# Technical Note

| <b>Project:</b>       | P21-390 – Burbage Fields Farm, Burbage, Leicestershire             |                  |                  |
| <b>Subject:</b>       | Response to Statutory Highways consultees on App Ref: 24/00083/HYB |                  |                  |
| <b>Document Ref:</b>  | 21390-RLL-25-XX-TN-D-5028                                          | <b>Revision:</b> | P01              |

**Figure 2: Extract from DMRB TD42/95 (now withdrawn)**

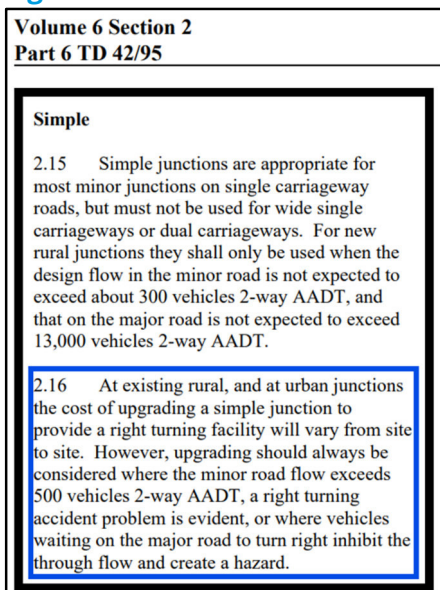
2.2.17 The selection of a site access junction form is nuanced and subjective based on the designer’s consideration of multiple factors and guidance documents. Whilst RL acknowledge LCC’s comment that DMRB guidance *can* be applied to non-trunk roads, its application is not always appropriate, with consideration of the below extractions:

- 2.2.18 Despite MfS2's reference to the now superseded TD42/95 DMRB guidance, the advice it provides in Section 9 is considered to remain relevant to the current DMRB CD123 design guidance. As shown above in **Figure 1**, paragraph 9.4.2 of MfS2 advises that DMRB is written "*specifically for trunks roads and, where used in other situations, should not be applied uncritically*".

**Figure 3: Extract from DMRB CD123**

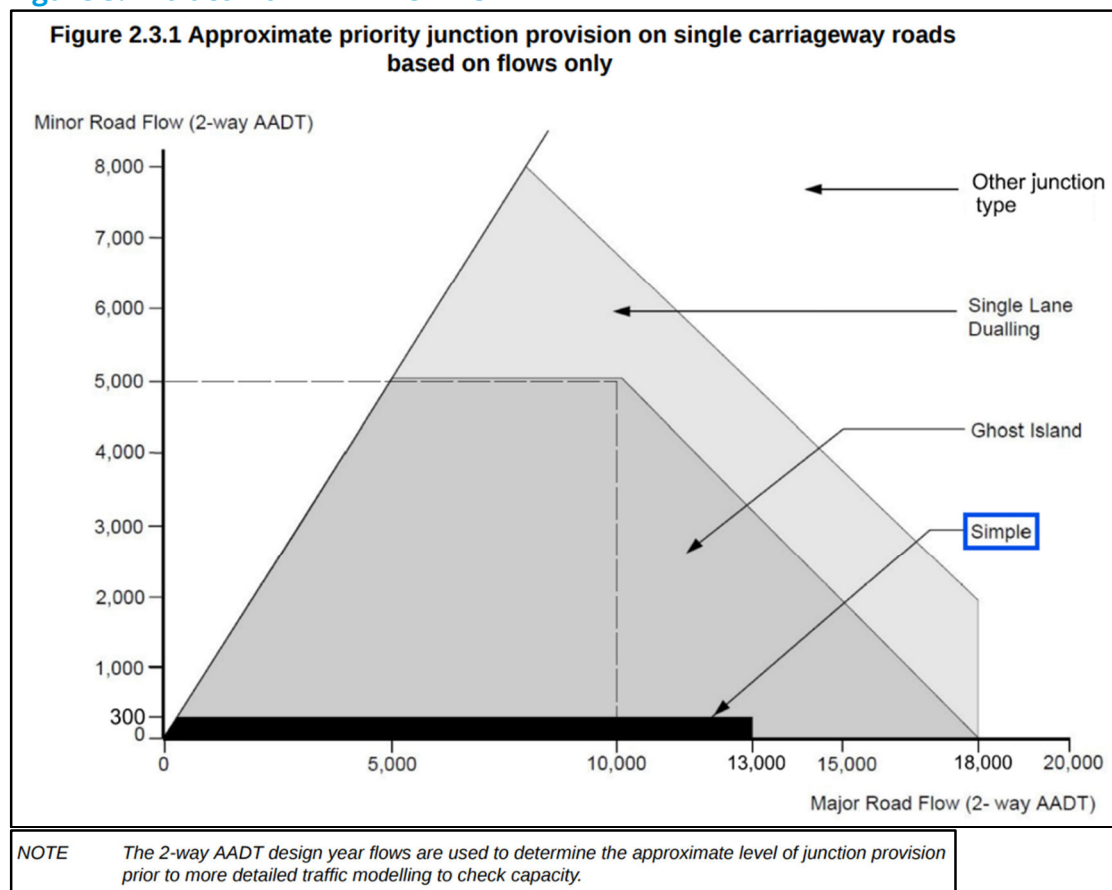
2.2.26 It is acknowledged that rigid application of the annual average daily traffic (AADT) minor arm traffic flow threshold identified in CD123, Figure 2.3.1, would necessitate the provision of a ghost island because the proposed development access (minor) arm is forecast to exceed 500 AADT.

**Figure 5: Extract from MfS2**

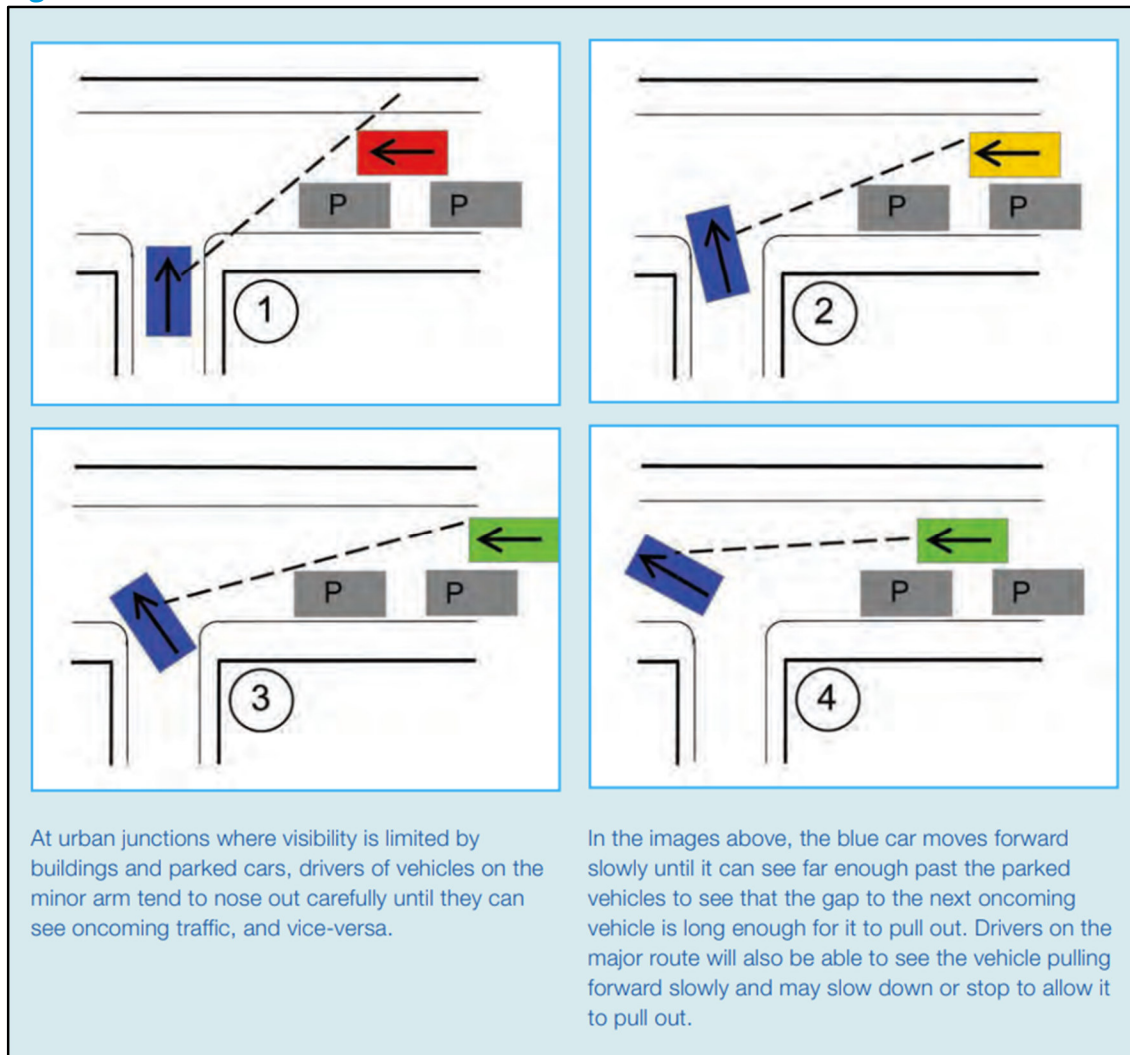
- 2.4.19 **Figure 5** (shown overleaf) has been extracted from page 80 of MfS2 and summarises driver behaviour in such situations and this behaviour should be considered in context with the existing situation along the length of Coventry Road.

Figure 1: Extract of Definitive Map of Public Rights of Way within proposed development

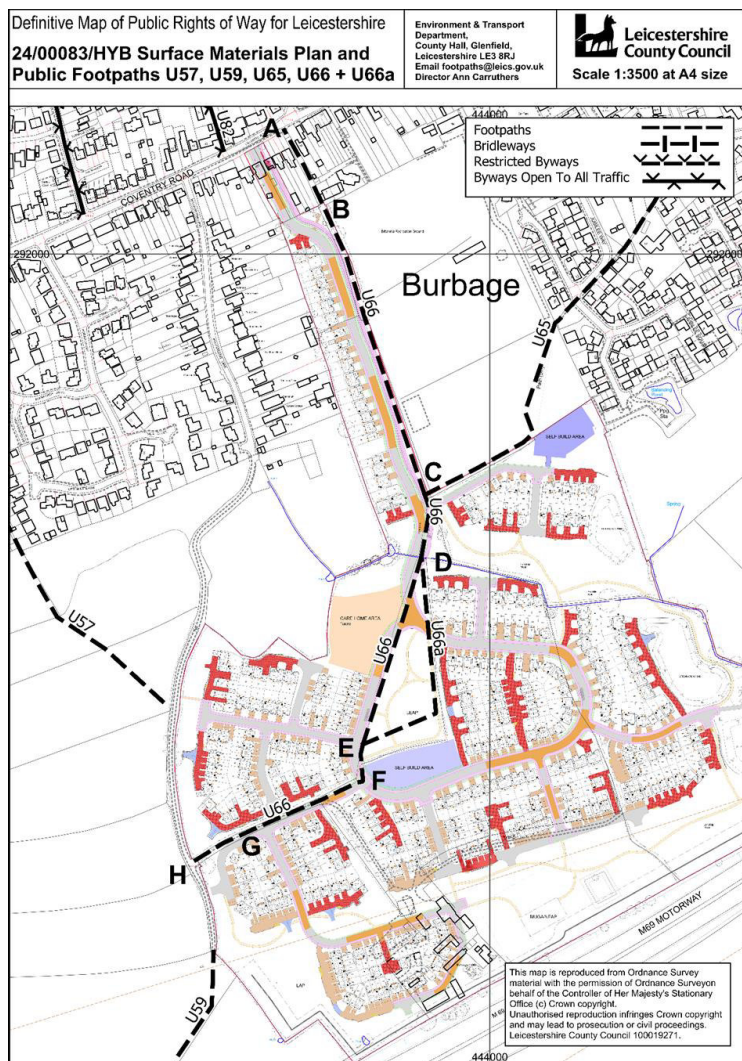
Included below is the latest submitted Surface Materials Plan (drawing no.1693-08-02-140 - Rev A) overlaid with the footpath routes as recorded on the Definitive Map of public rights of way, the official record. The Definitive Map legally 'fixes' the routes of public footpaths, bridleways etc. Routes on the ground may be different but, in law, the route on the Definitive Map is the alignment that must be used by planning proposals. If not, a legal diversion of the right of way will be needed.
